Access Compliance Report

Public Rights-of-Way

(Curb Ramps)

Intersection ID: 22200	Main Street: S_TRYON_ST	Cross Street: JOHN_PRICE_RD	Location: E
ADA ID: CA224A39EFDC	Ramp Type: Perp	Initial Pass/Fail: Fail	Overall Compliance: No
Severity Score: 22.5			
Codes/Mitigation Info/Possible Solution		Field Measurements/Component Compliance

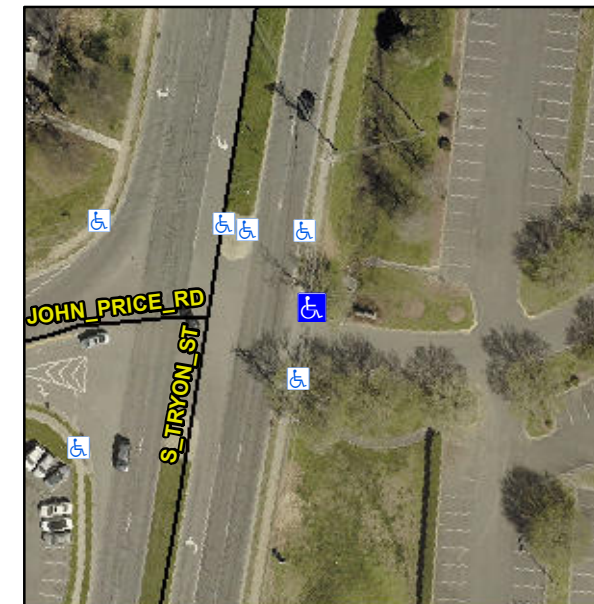
Not Found, R304.5.1, R304.2.2, R304.5.3

Compliance	Description	Data	Compliance	Description	Data
N/A	Ramp Length (in)	88.0	No	Ramp Slope (%)	10.5
No	Ramp Width (in)	40.0	No	Ramp XSlope (%)	5.0
N/A	Flare Type LT	N/A	N/A	Flare Type RT	N/A
N/A	Flare Slope LT (%)	N/A	N/A	Flare Slope RT (%)	N/A
N/A	Flare Traversable LT?	N/A	N/A	Flare Traversable RT?	N/A
N/A	Landing Length (in)	N/A	N/A	DWS Provided?	N/A
N/A	Landing Width (in)	N/A	N/A	DWS Contrast?	N/A
N/A	Landing Slope (%)	N/A	N/A	DWS Length (in)	N/A
N/A	Landing X Slope (%)	N/A	N/A	DWS Full Width?	N/A
N/A	Landing Curb? (Y/N)	N/A	N/A	DWS Offset (in)	N/A
N/A	Shared Landing?	N/A			
N/A	Gutter Ponding?	N/A	N/A	Gutter Slope (%)	N/A
N/A	Gutter Lip Ht (in)	N/A	N/A	Gutter X Slope (%)	N/A
N/A	Painted X Walk1?	No	N/A	Painted X Walk2?	N/A
	X Walk 1 Direction	To S		X Walk 2 Direction	N/A
N/A	X Walk 1 Width (in)	N/A	N/A	X Walk 2 Width (in)	N/A
	X Walk 1 Slope (%)	1.6		X Walk 2 Slope (%)	N/A
	X Walk 1 X Slope (%)	3.8		X Walk 2 X Slope (%)	N/A

Remove & Replace Entire Ramp.
